IMPORTANT SAFETY RECALL

NHTSA RECALL: 16V682
CANADA RECALL: 2016-459

Forest River – Office of Corporate Compliance (“OCC”) has decided that a safety defect exists in certain 2016 and 2017 model year Amera-Lite - ALDD610SA, ALDR610SA, ALDD612SA and ALDR612SA. Forest River is recalling the defect model(s) to ensure the safety of our future retail consumers and your dealership. Forest River apologizes for any inconvenience this action may cause your dealership; however, safety continued satisfaction and our commitment to building great products are of the utmost importance to Forest River.

SECTION A-A

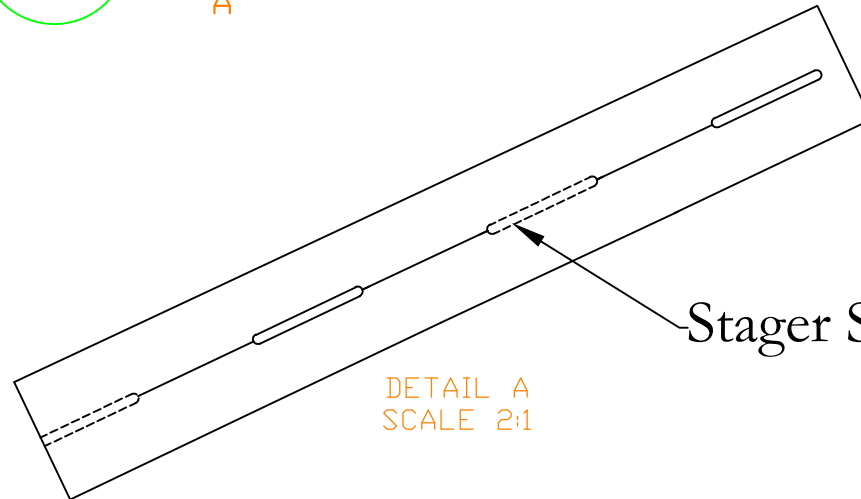
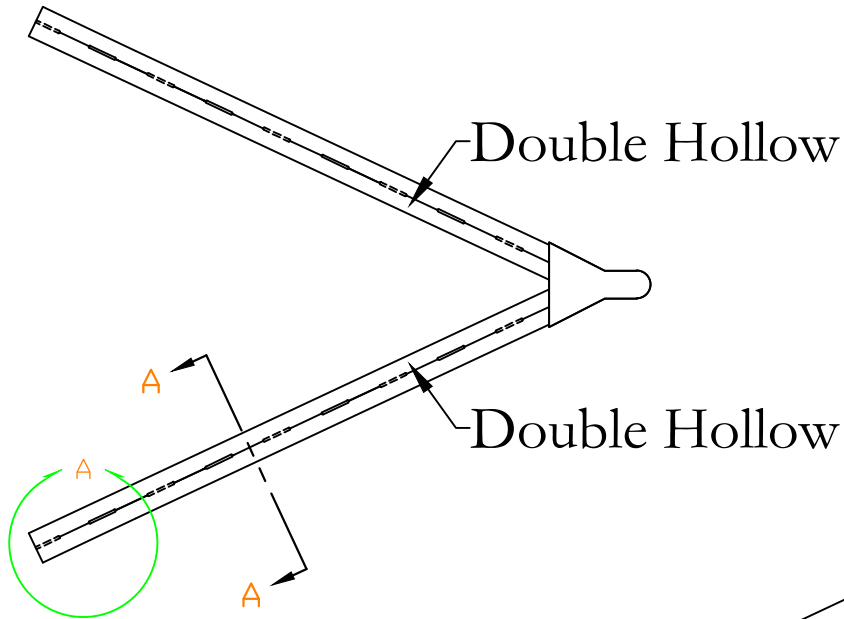
The drawbars and coupler welded to the vehicle are out of specification for the vehicles’ Gross Vehicle Weight Rating (“GVWR”).

The drawbars have an elevated risk of fracture and full failure while traveling. Should the drawbars fracture or fail, the vehicle/trailer has an elevated increase to cause a crash.

Dealership Service Department Service procedures for addressing 2016 and 2017 model year Amera-Lite - ALDD610SA, ALDR610SA, ALDD612SA and ALDR612SA, please review and follow instructions on the Print, included with this document.

DESCRIPTION OF PART	QUANTITY PER KIT
2" x 3" x .25" DOUBLE HOLLOW; STEEL TUBE	2

UNITED STATES	CANADA	REPAIR CODE	DESCRIPTION	ALLOWABLE HOUR(S)
16V682	N/A	21-000682	ADD TUBE TO A-FRAME	1.00
N/A	2016-459	21-000683	ADD TUBE TO A-FRAME	1.00

Inside DB Tube Outside DB Tube

Stager Stitch Welds Top/Bottom

DETAIL A
SCALE 2:1
